Majestic Manufacturing, Inc.

Subject: Lap Bar Cylinder Mounting Position

SERVICE BULLETIN

S.B. Number: 92-6 Sheet 1 of 2

Notice:
Figure 1.

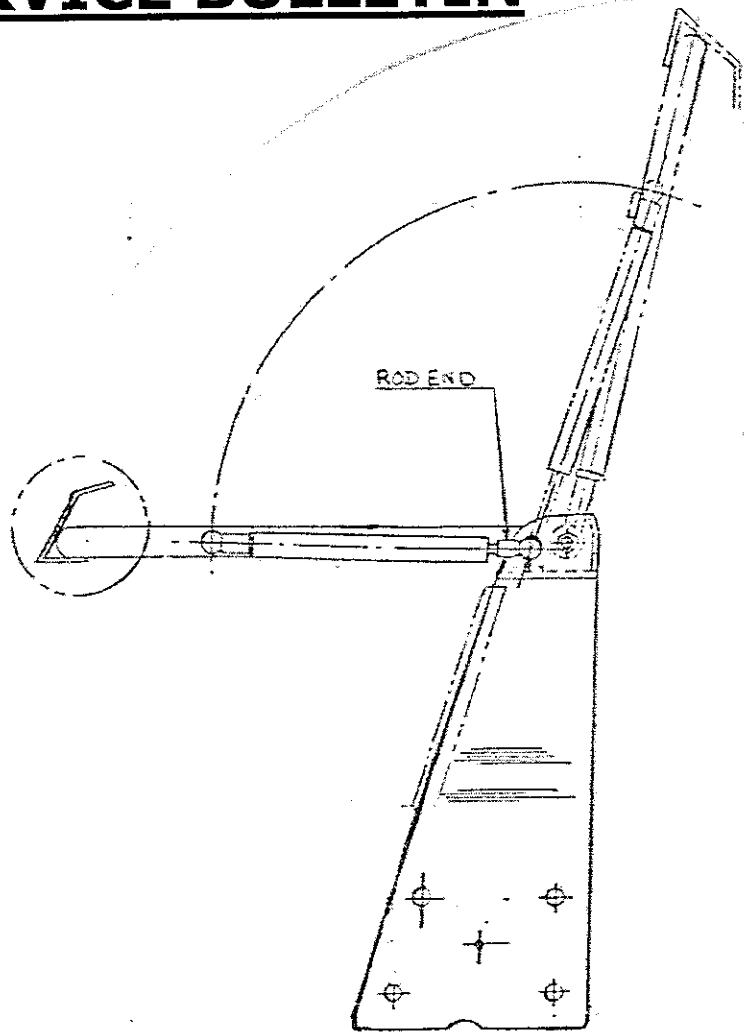
It has been brought to our attention that if the spring cylinder, in the lap bar, is mounted in a reversed position; the lubricating oil inside the cylinder will be drained away from the rod bushing, which could cause premature failure of the cylinder.

All customers with Majestic lap bars installed in their scooter bumper cars are being notified by this service bulletin to reverse their cylinders so that the rod end of the cylinder will be in the position as shown below in figure 1.

The cylinder can be removed by inserting a screwdriver or knife under the spring clip on the end of the cylinder and prying it up, which will release the cylinder end from the ball stud. After reversing the cylinder, push the spring clip down to secure the cylinder to the ball stud.
